Northern States Power Company

PRAIRIE ISLAND NUCLEAR GENERATING PLANT
Docket Nos. 50-282 License Nos. DPR-42
50-306 DPR-60

Clarifying Information in Support of Exemption
Requests for Fire Areas 58, 59, 73 and 74

Drawing Description and Expanded Fire Hazards Analysis

Dir of NRR
Enclosure 3
Figure 1
May 16, 1983

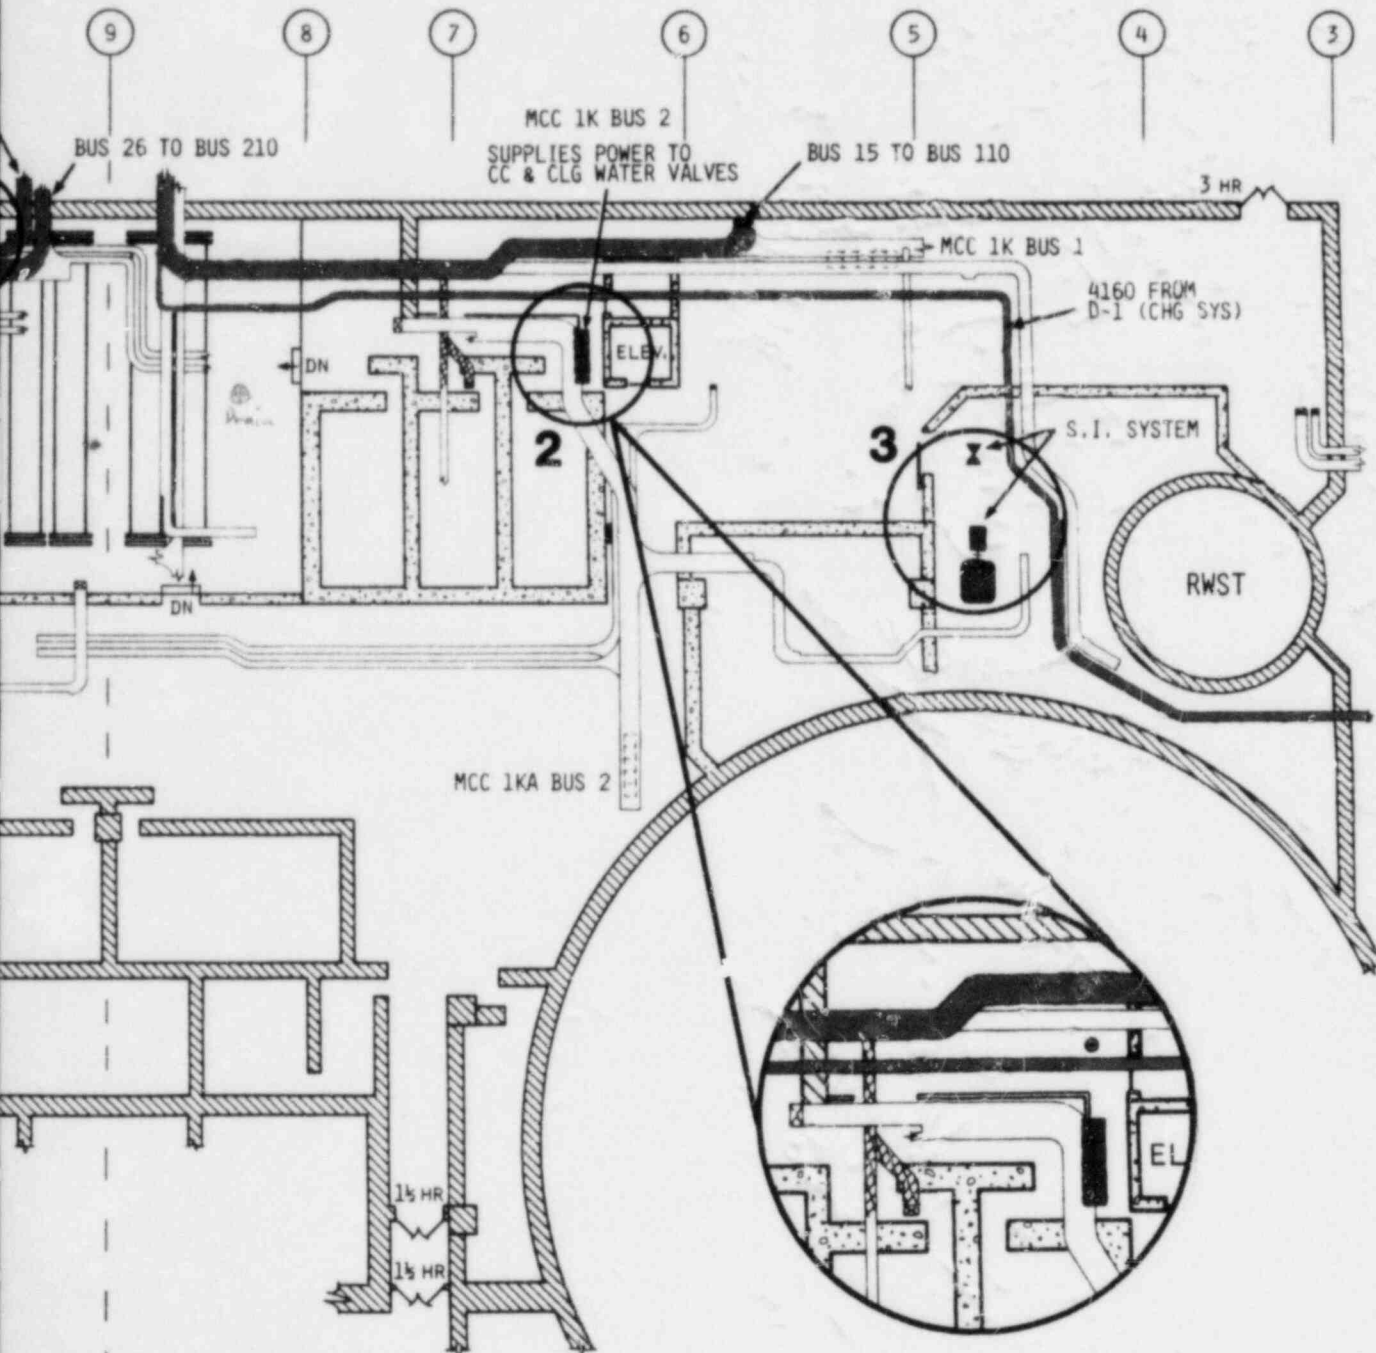
In reviewing the drawings three significant locations have been identified where it may appear that fire could damage both an unprotected "A" train cable tray and a redundant "B" train component. These locations are labeled 1, 2 and 3 on the Figure 1 drawing. All of these particular locations are on the ground floor of the Auxiliary Building. This area is both a radiologically controlled area and a vital area with dual access controls and is not a normal traffic path. Dual access controls refer to the emergency exit doors which make it difficult to transport flammable material into this area because:

1. In this location a cooling water valve which supplies the component cooling heat exchanger for maintenance of reactor coolant inventory (B train) is located near cables which supply 4160V power to the "A" train 4160V/480V safeguards transformer, and control cables for the A train charging pump, also for maintenance of reactor coolant inventory.

2. In this location the motor control center supplying power to component cooling and cooling water valves supporting the reactor coolant inventory function (B train) is located near D-1 diesel generator control cables, 4160V power cables from the diesel, and 4160V power cables to the 4160V/480V safeguards transformer which supply A train power to safe shutdown equipment.

3. In this location the safety injection pump and suction valve supporting the reactor coolant inventory function (B train) is located near D-1 diesel generator power to the safeguards bus supporting "A" train safe shutdown functions.

- a. The floor area beneath these components is actually a pit in which the four component cooling water heat exchangers exist and is provided with a very effective drain system to handle any leakage from the heat exchanger cooling water side which would prevent the accumulation of combustible fluids.

- b. The heat exchangers and piping in the area would provide thermal shielding between the trays and valve overhead and a fire on the floor.
 - c. The distance from the floor to the trays is 16 feet.

- d. This area is not a normal maintenance work area and is not a normal traffic path. Radiologically contaminated, controlled access areas exist on the east and west sides of the heat exchanger pit leaving only one access on the south side. Difficult access to the area makes it highly improbable if not impossible to envision the accumulation of combustibles in the area.

- e. Since B train trays will be wrapped as described in the Exemption Request of March 11, 1983, the B train charging system will remain free of damage and will provide the reactor coolant inventory control and boration function.

- a. The motor control center is mounted on a concrete pedestal 4 inches high which would prevent combustible fluids from getting under the MCC.
 - b. A floor drain is provided 3 feet north of the MCC.

- c. The front of the MCC is shielded by a floor mounted 4 foot high steel fence which is sealed at the base preventing seepage of any fluid in front of the MCC.

- d. Horizontal separation of the MCC and the nearest tray is 8 feet and the tray is 14 feet above the floor.

- e. This area is not a normal maintenance area and not a normal passage way. In fact it is a dead end area blocked by the concrete wall and steel fence which surrounds a contamination control area. This area is visited once every four hours by the operating staff during normal rounds.

- f. The arrangement of fixed structures in the area, drainage and frequent surveillance makes it highly improbable if not impossible to accumulate any amount of transient combustible in the area. Therefore, there is no threat of a fire which could damage both redundant functions.

- g. In order to completely defeat Unit 1 make-up inventory control (assuming loss of offsite power), a fire would have to disable supply breakers on MCC-1K2 for #11 charging Pump (train B), #13 charging Pump (train B) and a Safety Injection system component (train B), as well as the D-1 diesel (train A) control or power distribution cables. Considering the partial protection afforded by the 4 foot steel wall and the steel enclosure of MCC breakers, this is deemed to be highly unlikely for a fire between MCC-1K2 and the D-1 control/power cables.

- a. Since B train trays will be wrapped as described in the exemption request of March 11, 1983, the "B" train charging system will remain free of damage and will provide the reactor coolant inventory control and boration function for No. 12 Safety Injection Pump.

Dir of NRR
Enclosure 4
Schedule A
May 16, 1983

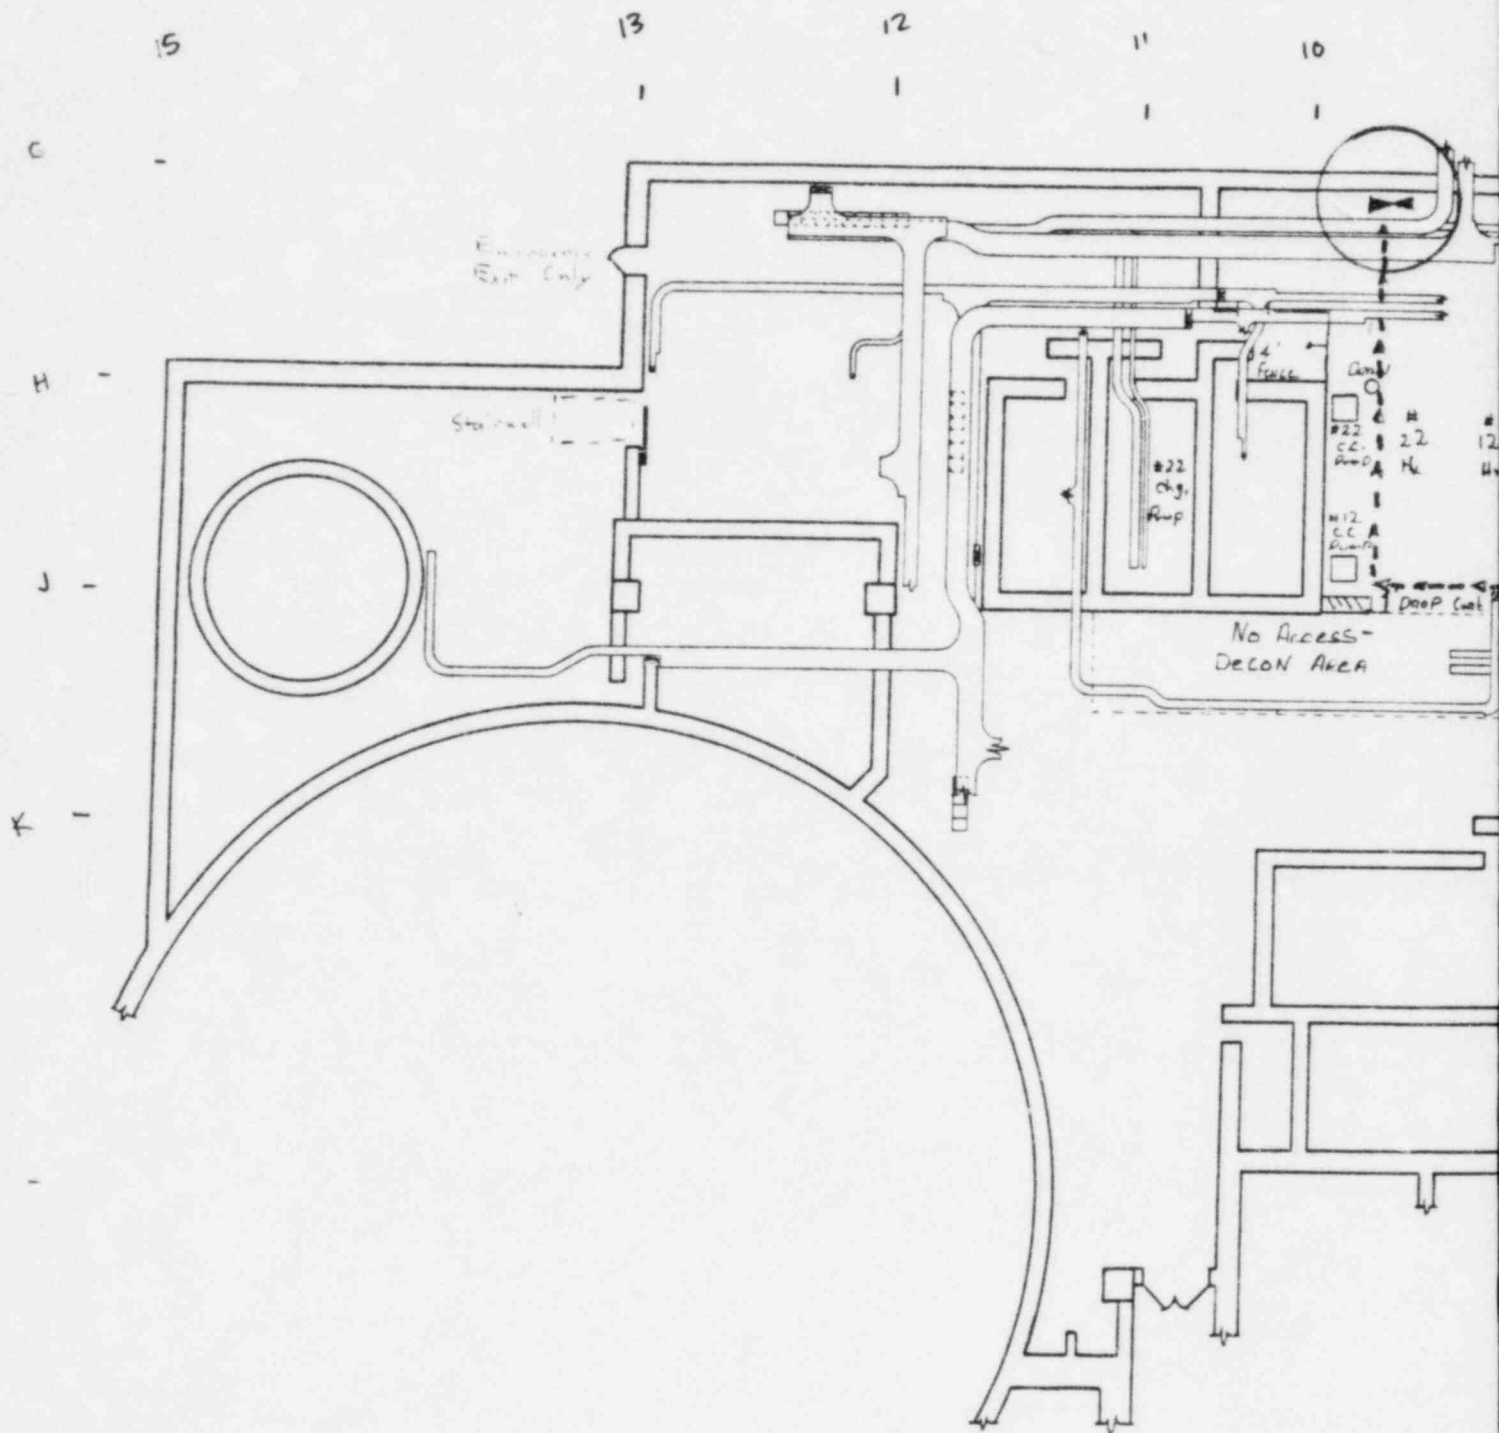
Schedule A of enclosure (4) along with accompanying pictures, provides a photographic tour of this area. The area is routinely patrolled by the plant operations staff every 4 hours. In addition, there two Auxiliary Building operators on duty in the "operator shack," 24 hours a day. This location affords a general view of the elevator and various traffic paths personnel can take through the area. Schedule B of enclosure (4) shows these traffic paths and the inconvenience and difficulty of transporting combustibles to location of concern in those fire areas. It is inconceivable that transient combustibles could accumulate in these fire areas in sufficient quantities to threaten both trains of redundant equipment in the area at any location. Due to the factors listed below, a) locations 1, 2, and 3 are even less probable to be the site of an accumulation of combustibles, and b) it is demonstrated that protective features exist which ensure that at least one train of safe shutdown equipment will remain free of damage.

* 2-Operators on duty 24 Hrs. A Day.
Windows on ALL 4 Sides of "Shack".
Has View of ANYONE/Anything coming off Elevators.
(ONLY WAY to Move any Large Volume of combustible)

▲ Normal Entrance to C.L. Pump / H₂ Area
From Elevator
